23 Ravenshaw Street London NW6 1NP
2017/0911/P

Response to the Design Review Panel's Comments

12/12/2018

Fig 1: 64% of the building is ad-hoc later extensions - shown in pink.

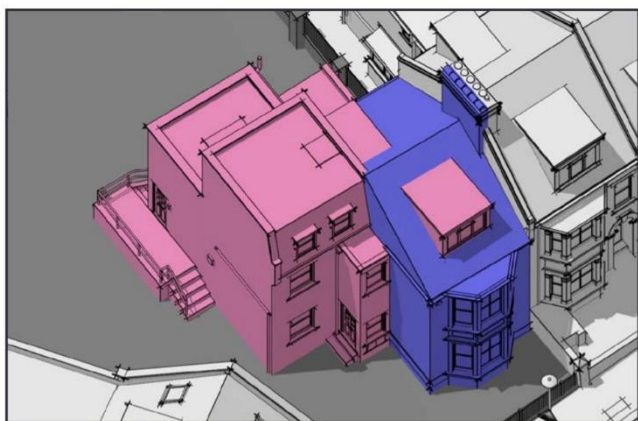
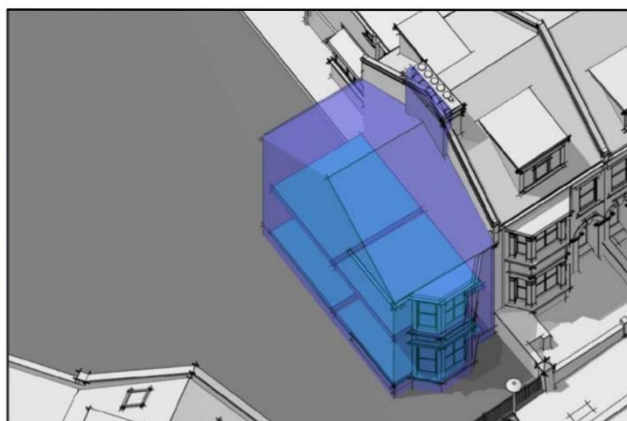
'building on site of higher quality architecturally..'

Many Victorian buildings make a significant heritage contribution to the built environment; but No.23 Ravenshaw Street is not a good example. The existing house is a very unremarkable building and makes a negligible historical contribution. The original Victorian house was a comparatively small and basic two-up and two-down, comprising of just 60m² GIA. We cover these arguments in detail in the following documents.

Above: Sectional CAD view is not demonstrative of actual visibility, impact or harm.

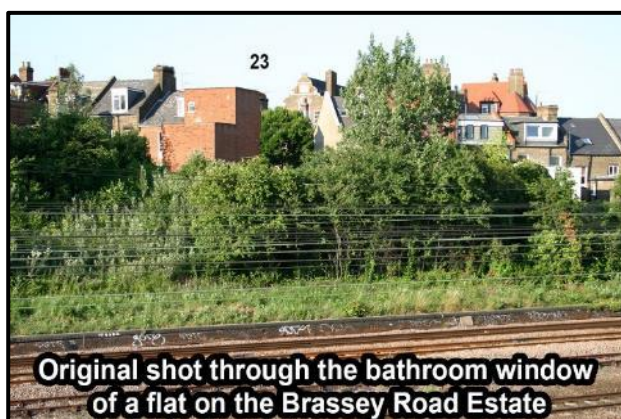
Design Review officers suggested that the development constitutes 'over-development'. They stated that the rear elevation was 'excessive', and that they had a 'general feeling' that too many units were being proposed. We would argue that the development does not constitute over-development in terms of:

The bulk and massing presented in the rear CAD elevation can not be seen from any public or private viewpoint. The views shown in the CAD elevations faces only the railway bank. Very little of the rear elevation could ever be seen at all from the public realm and private real views are very restricted.

Above: The impact of the two rear facades is all directed towards the railway banking. Only glancing views over walls are possible from gardens to NW and SE.

Revised façade

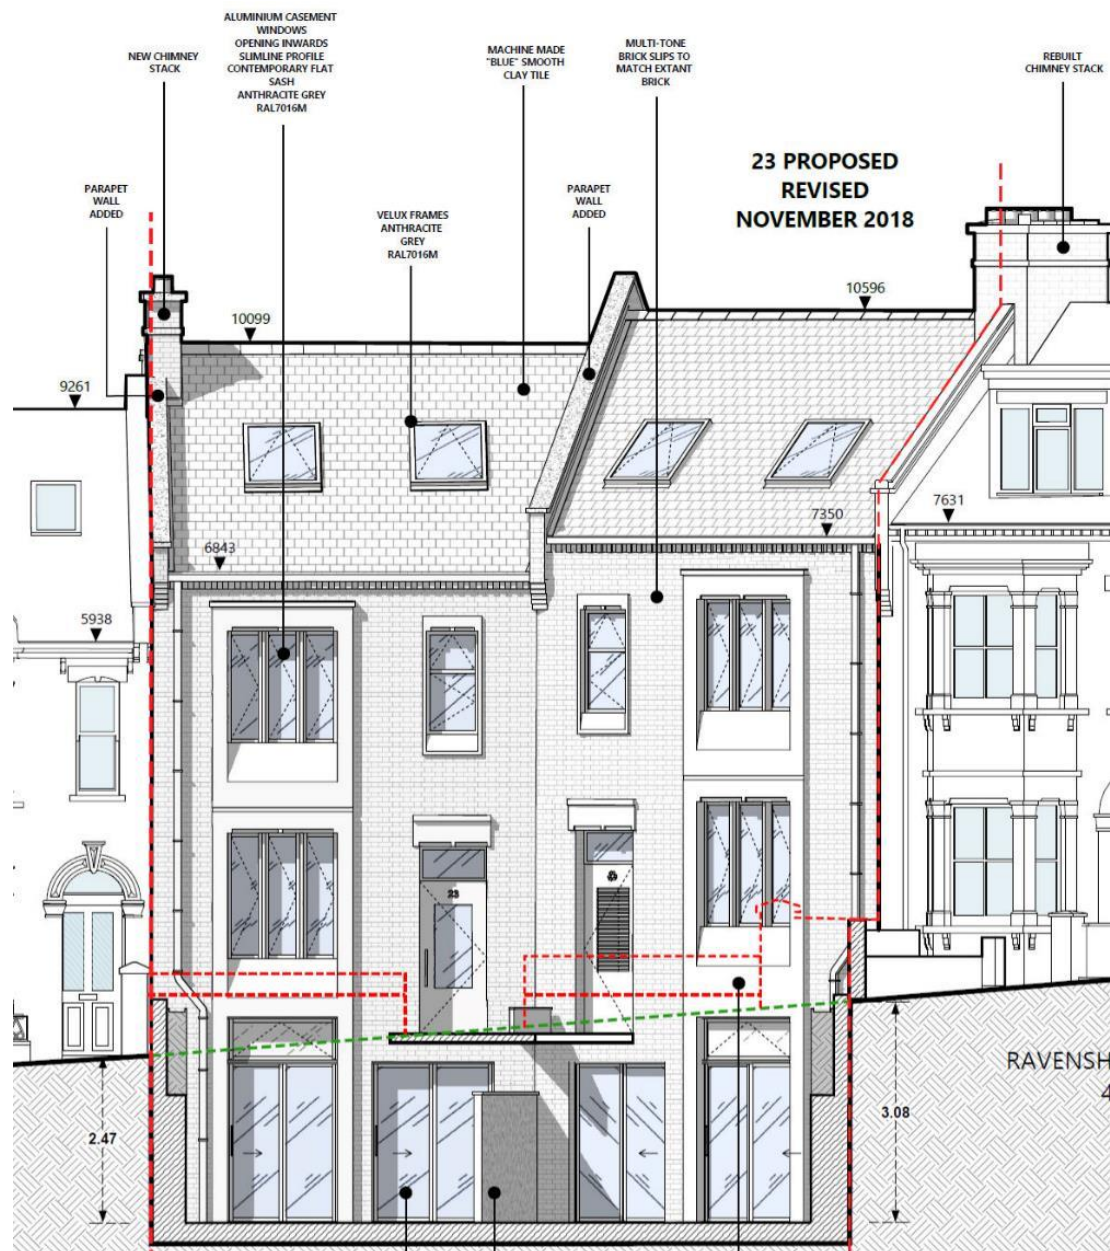
About the proposed façade, officers remarked: *'Although there were no complaints about the height and scale, the modern design was considered to be out of keeping with the context of the street'*.

'context is slate rather than zinc.'

In light of your officer's views, accompanying this document is an alternative front façade treatment which takes a slightly different tack to achieve what is still a contemporary design. **These revisions do not render the application a 'substantially different' scheme.**

The design is now less assertively contemporary. We hope it will be regarded by officers as being more suitably 'residential' in the way its white render window surrounds now alludes more strongly to adjacent bay windows. Parapets are introduced, along with a smooth blue clay slate tiles, reflecting adjacent welsh slate, instead of the standing seam metal roof. These limited revisions are designed to tie the front façade into the existing street scene to a greater degree by responding more directly to the Victorian vernacular to either side.

- Grey façade panels swapped for a white render faux bay design - windows amended but virtually the same size and position.
- Entrances revised to match
- Two parapet walls
- Slate instead of standing seam roof

- Slate instead of standing seam roof
